Car Stereo
Service Bulletin

Model: CDX-A20

No.152R1

Subject: Improvement of Signal to
Noise Ratio

FIG. 1

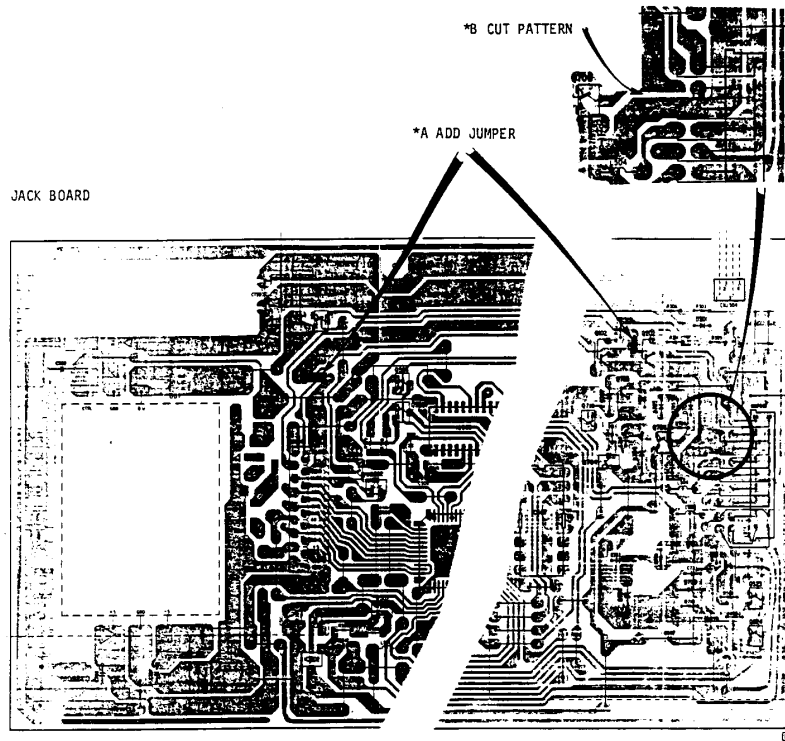
1. Replace "RF" Board.
2. Re-adjust Focus and Tracking Bias.
3. Modify the Jack Board (Diagram 1).
4. Add Jumper between "RF" Board and Antenna Shield Board.
